Project Name: Olympia Crest Apts III
Concept Design Review

Project Number #: 21-1161
Date: May 13, 2021

CITY OF OLYMPIA
MULTI-FAMILY RESIDENTIAL
Chapter 18.170

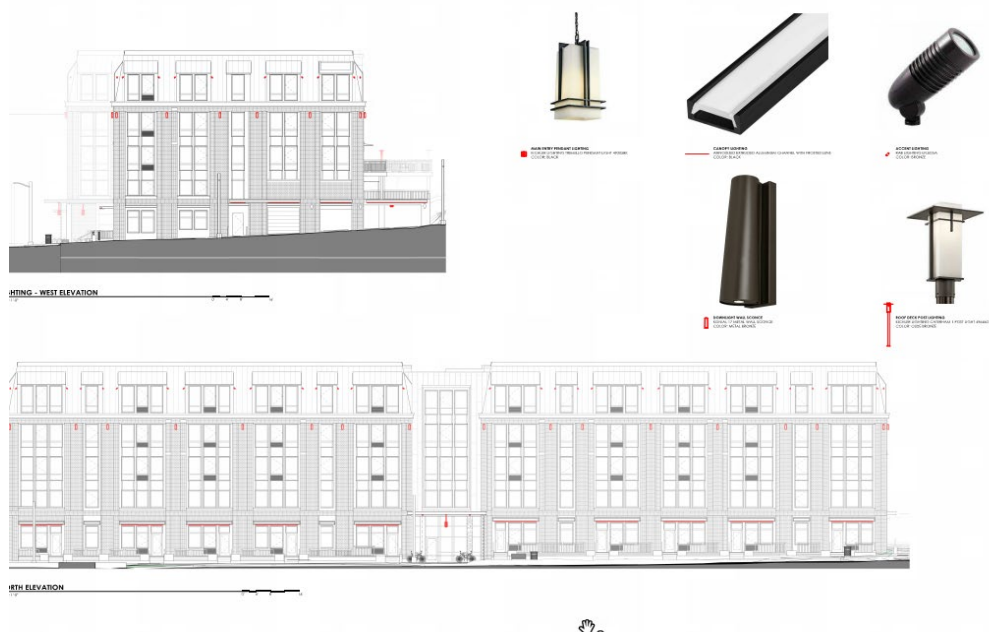
The project narrative mentions bollard lighting along the pathway, similar to what exists along the pathway on the adjacent Phase II development. At the next stage of design review the Board will need to see all choices of site lighting around the buildings and around the site. This includes photos and design details of the bollards along the pathway. An example of what this might look like is provided in the detail elevations below. Locations and photos of

lighting over entries, stairwells, in the parking areas, and in the play area, for example, should be easily identifiable in the architectural plan set. It is important that lighting enables people to be comfortable where they are, provides easy navigation and prevents the potential of entrapment areas.

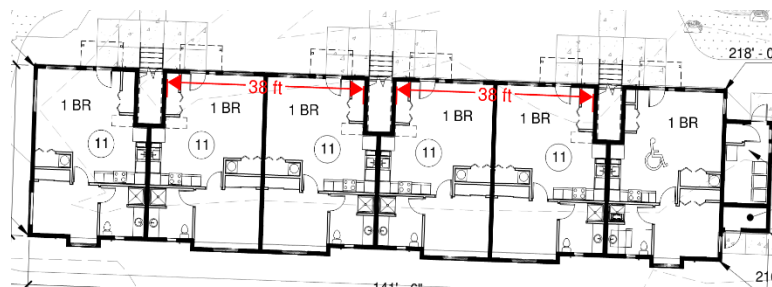
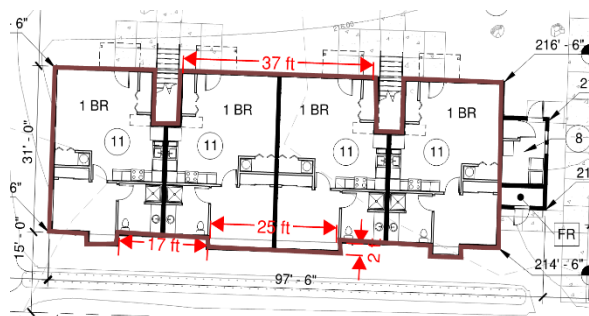
There are expanses of walls on the (front) facade of the buildings that are over 30' in width. In these areas the wall plane is flat, although there is a canopy above the residential entries. Building modulation helps break up flat planes, gives buildings depth, dimension and separation, as in fenestration, and adds interest to the building. Options for breaking the expanse of these wall sections might include decks, balconies, window bays, sunshades, porches, building bump-outs, or other.

- Modify the (front) facades of all three buildings to address lengths of walls greater than 30' in width, pursuant to the requirement.

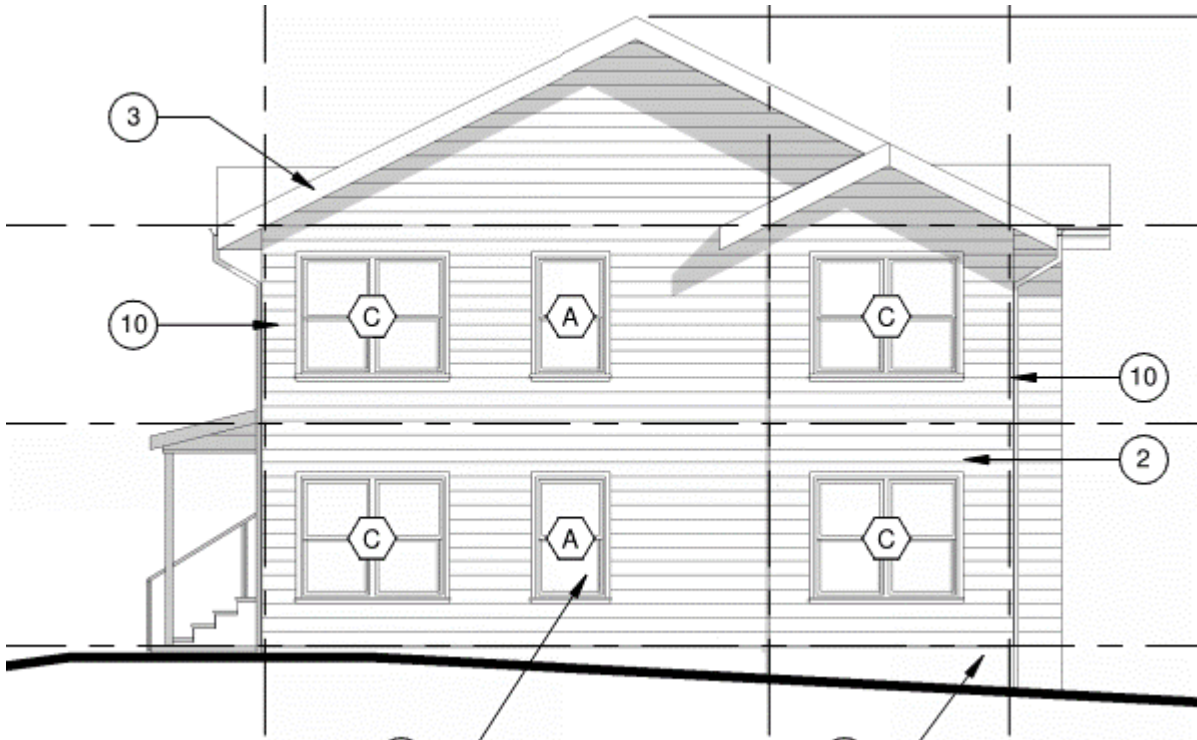
Applicant Response: We believe vertical windows don't match the existing apartments on this property and did not use them for this reason.

Windows on east and west walls are located such that privacy between the ends is maintained – refer to sheets DRA4.11- 4.13, Attachment 4. Windows around the buildings also appear to have extended frames (protruding) with multi-panes, muntins, possibly sills, and appear to be horizontal and vertical sliding windows – all of which add interest and functionality.
